Reference: Control Number 617996 – Response to RAI

**Subject: REVISION TO S. SCHLITT LETTER OF MARCH 23, 2020
RENEWAL OF MATERIALS LICENSE 20-23981-01E**

PROPOSED LABELING OF ELECTRON TUBES

JW NORTH AMERICA, INC. (LICENSE NO. 20-23981-01E)

EXAMPLE 1: Cosmedico Branded Lamps and Packages

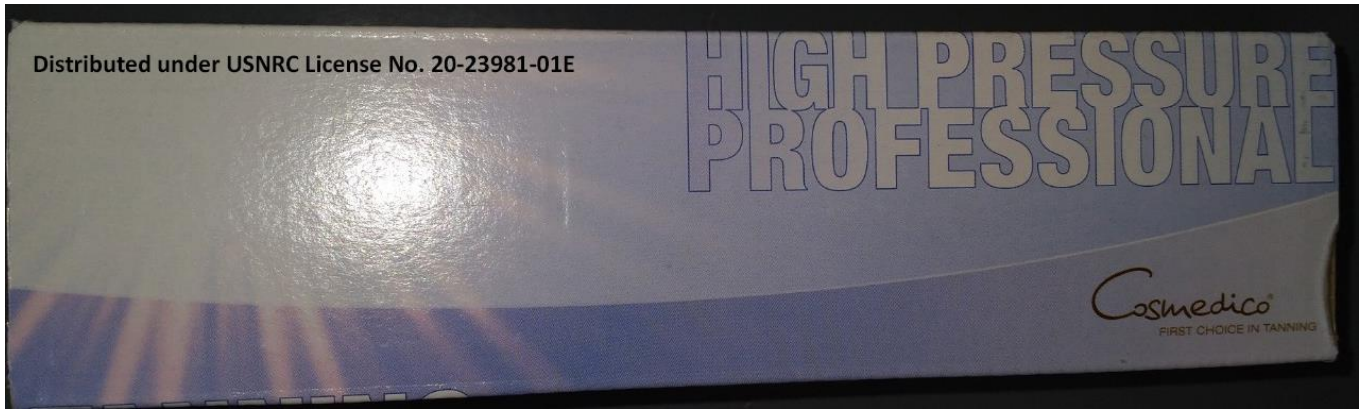
In the examples of the proposed labeling of the immediate containers that I presented in my letter, I showed labeled containers with the name and address of the actual manufacturer located in Germany. After a brief review of our proposed labeling presented in our letter, you informed me today that it is the intent of the regulation to require that the name of the Initial Transferor or Licensee, appear on the units and on the containers, and not the actual manufacturer, if the Manufacturer is not the Licensee. In our case the manufacturer is NOT the Licensee. You had also indicated to me that a reference to the Materials License Number could be substituted for the legal name of the Licensee.

In consideration of the information that you provided in your email to me today, we are amending our original proposed labeling. On the following pages, you will see graphical images representative of a variety of different lamp containers that we use and how we propose to label them in accordance with regulations. We intend to label all other containers in our product line in a like manner.
